# 1101 WESTERN AVE

Early Design Guidance #2  
SDCI # 3033606-EG  
July 9, 2019

SUMMARY OF BOARD COMMENTS: EDG #1

# EDG #2 - REVISED MASSING OPTION 1

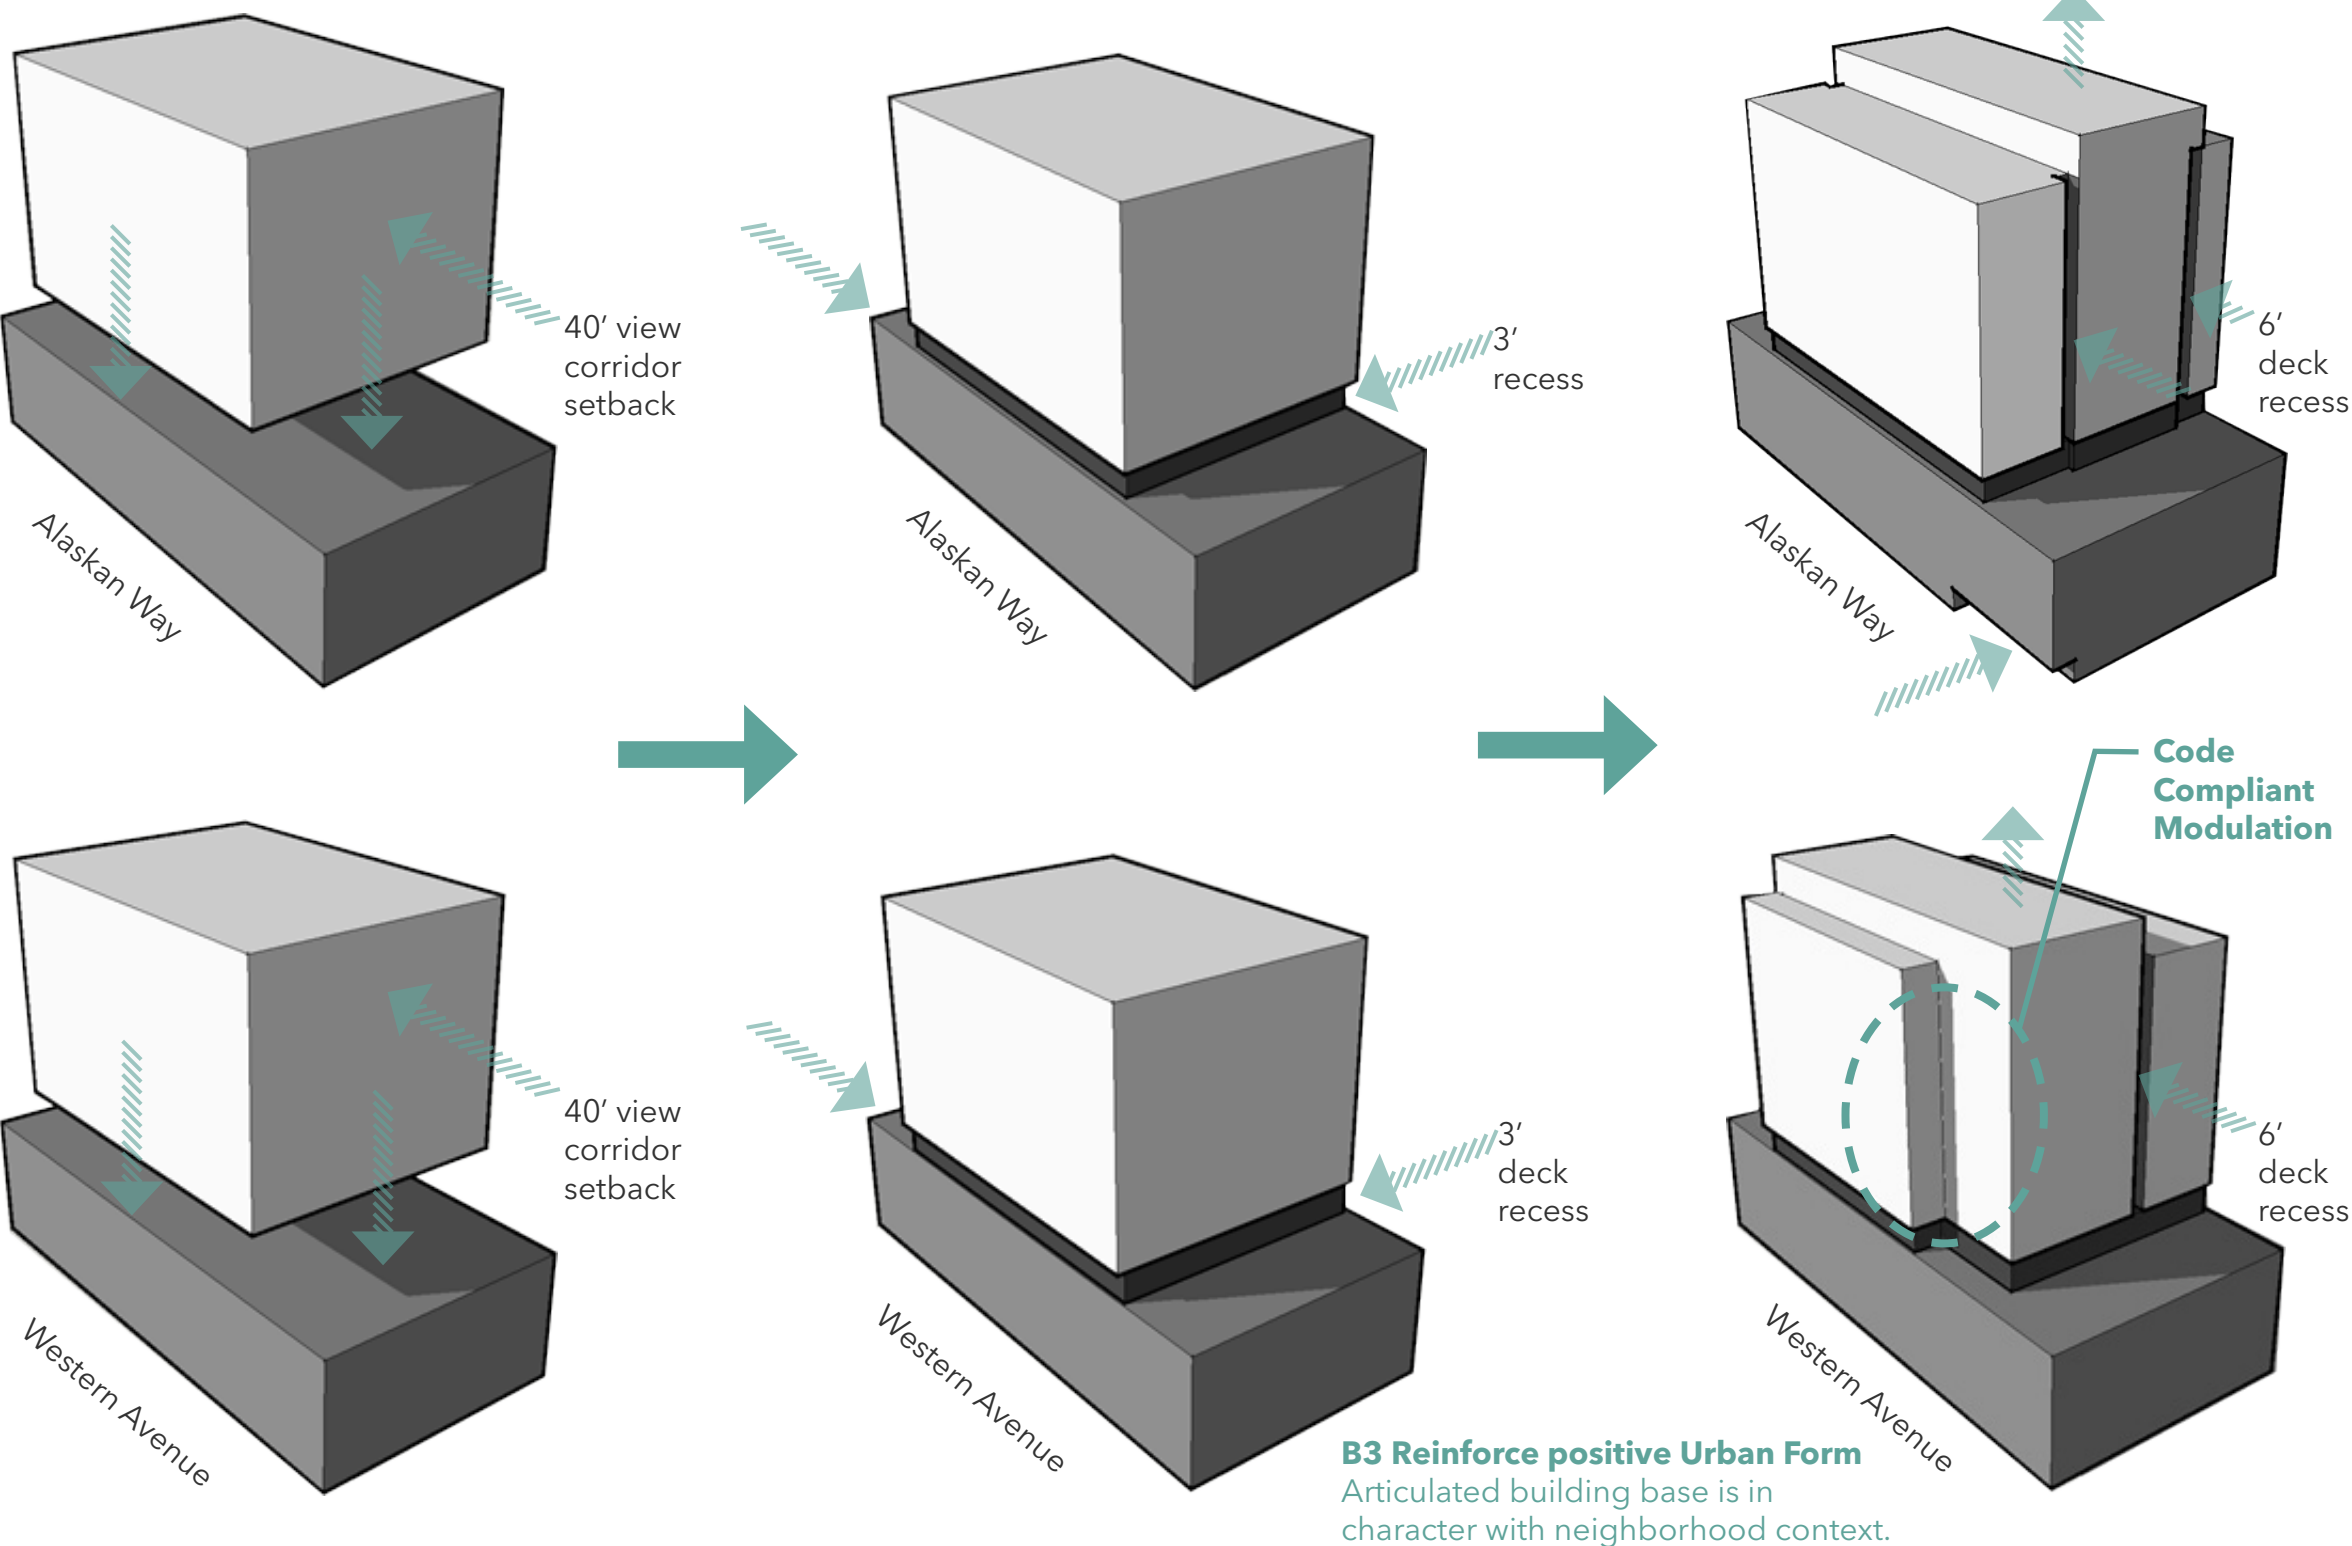
The Board requested two distinct massing options that respond to the physical environment (A1), Enhance the Skyline (A2)

Option 1 takes a resolute approach to neighborhood precedent of Base/ Middle/Top by articulating a solid base and utilizing deck recesses and code driven modulation to create slender tower forms.

Ground Level Plan

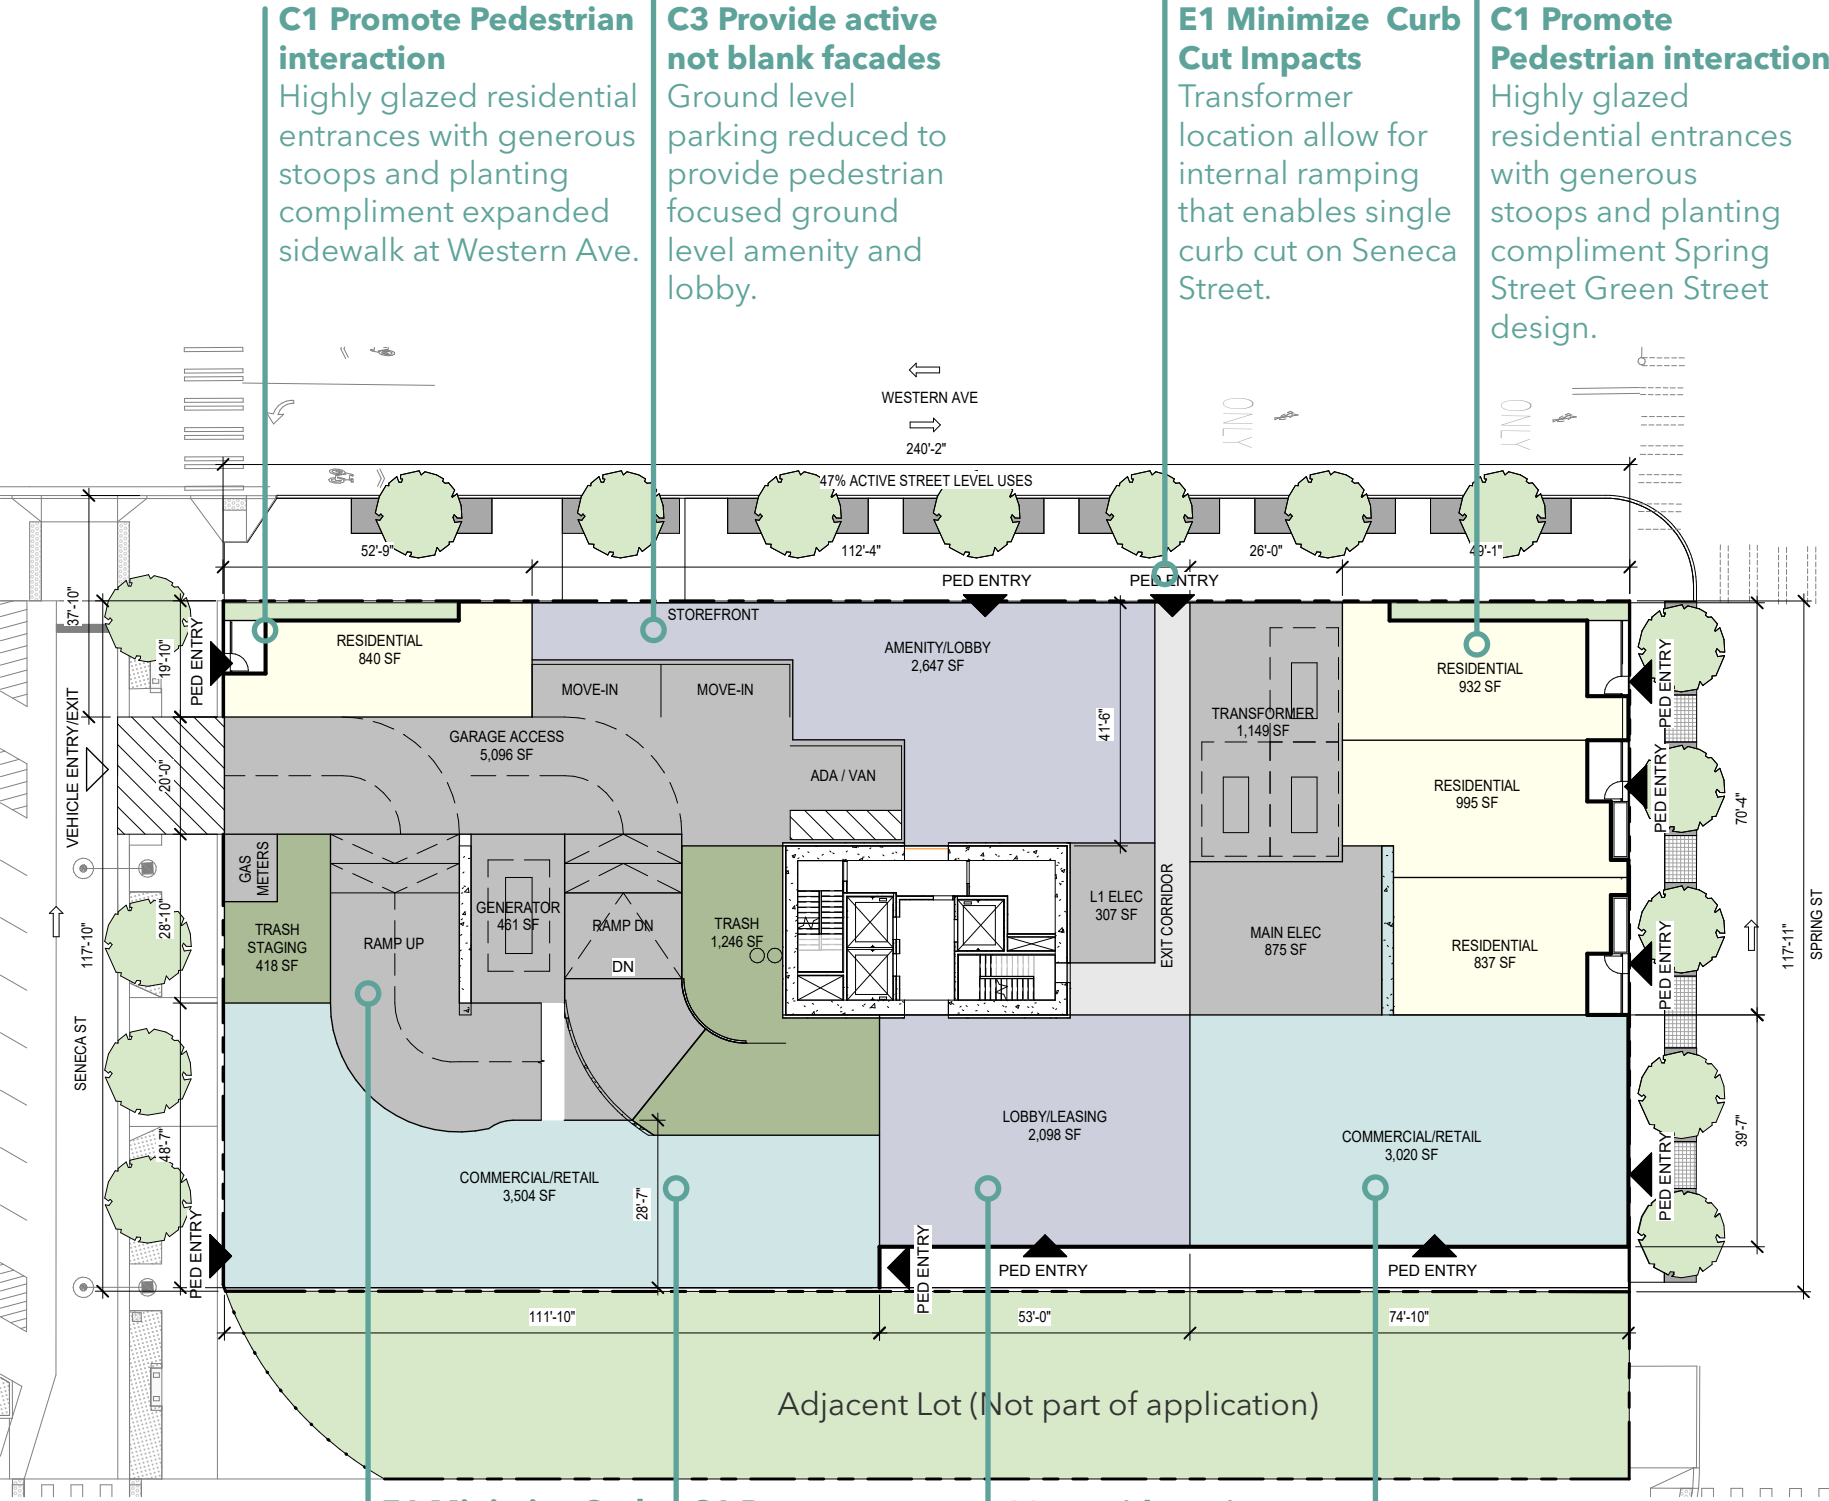
**Schemes presented at EDG #1 were too similar proposed residential, solid waste staging, parking and service room uses on Western were not supportive of the neighborhood context and a pedestrian environment.** In response Option #1 locates driveway access curb cut and trash staging on Seneca, designed a ground level without parking fronting on Western Ave. and eliminated the need for multiple levels of above grade parking visible on Western. The Board also requested residential precedents on Western.

**C1 Promote Pedestrian interaction**  
Highly glazed residential entrances with generous stoops and planting compliment expanded sidewalk at Western Ave.

**C3 Provide active not blank facades**  
Ground level parking reduced to provide pedestrian focused ground level amenity and lobby.

**E1 Minimize Curb Cut Impacts**  
Transformer location allow for internal ramping that enables single curb cut on Seneca Street.

View of Southeast Corner from Western Avenue

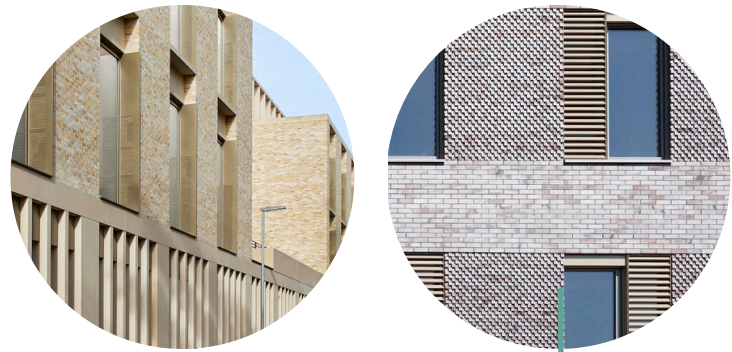
The Board was concerned about multiple levels of parking along Western Ave at the floors above the street level as this use will not help to activate the street. The Board requested that the design team provide a design at the floors above the street level that reinforces the features found in the neighboring buildings. The Design team explored alternative design solutions for above grade parking. Because of the high water table and porosity of fill soils only one level of below grade parking is proposed. The design team was able to accommodate all above grade parking at a single level, Level 2. Option 1 conceals this parking by integrating screens into the punched expression of openings in the masonry building base and achieves The Board's goal of minimizing above grade parking at Western Ave.

Punched openings in masonry are infilled with mesh or perforated panel, concealing upper level parking at Level 2 while integrating with the language of the masonry expressed at the building base.

# ELEVATIONS - OPTION 1

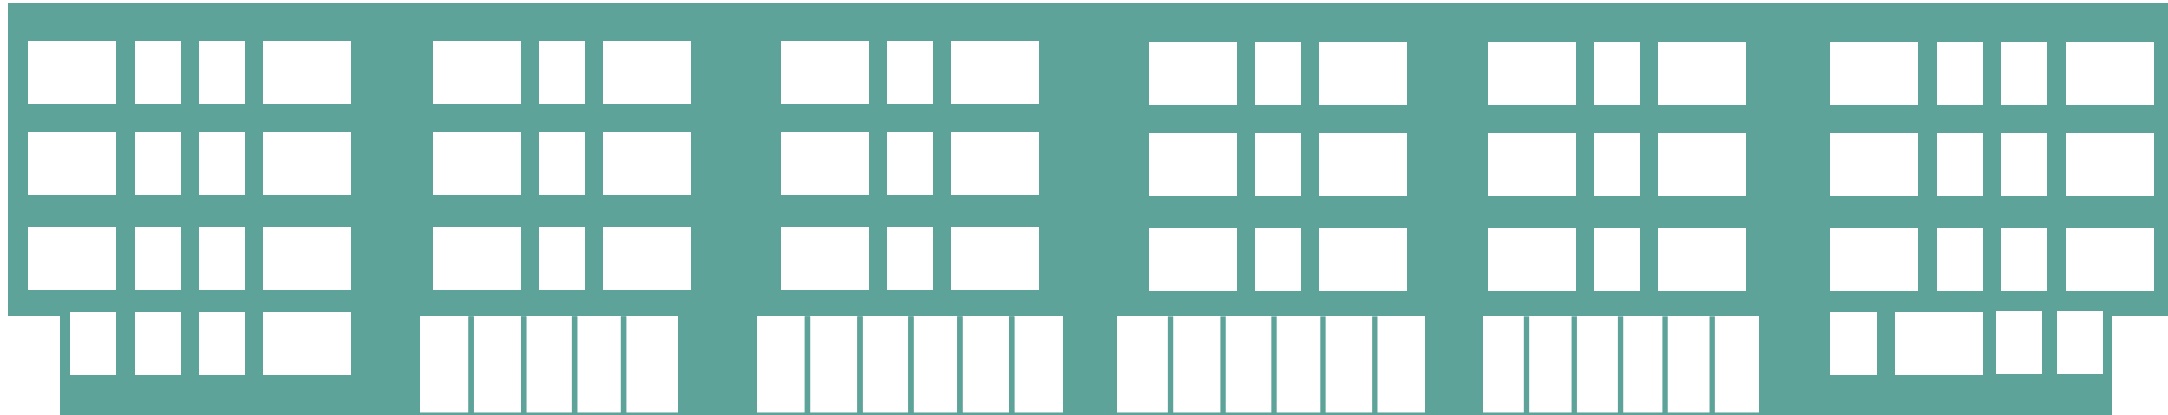
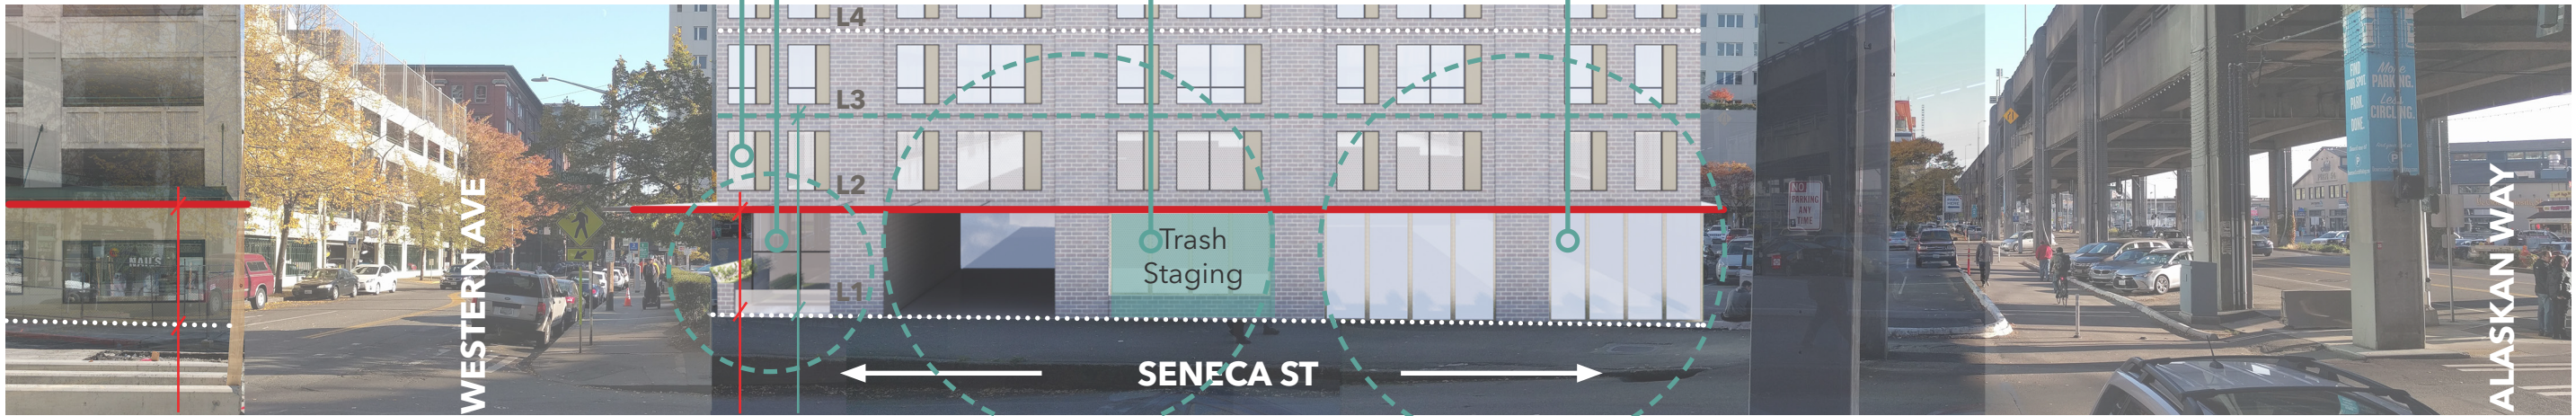
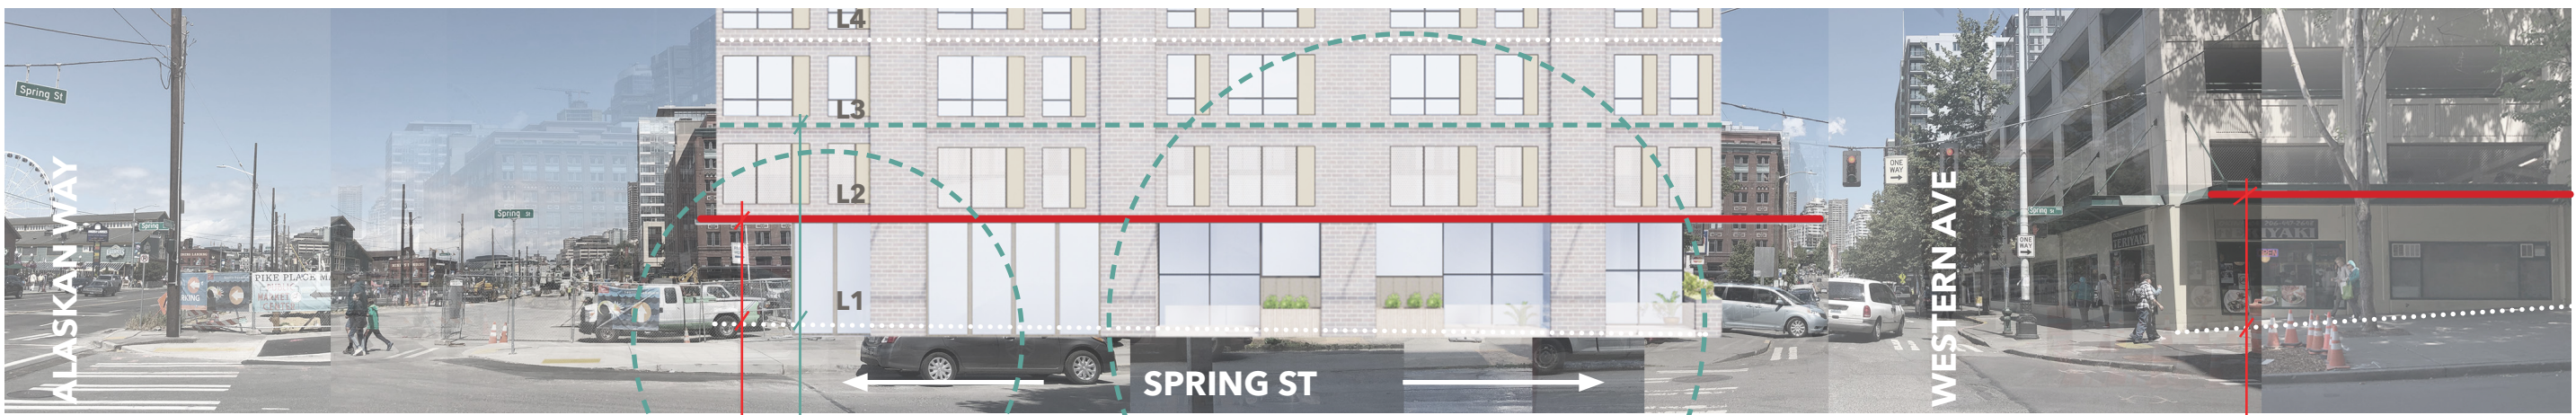
Response to Additional Board Requested Study 3f.

**E2 Minimize the visual impact of parking**  
Parking screening is fully integrated into the punched expression of the masonry base.

Note: Height of canopy expression consistent across Western St.
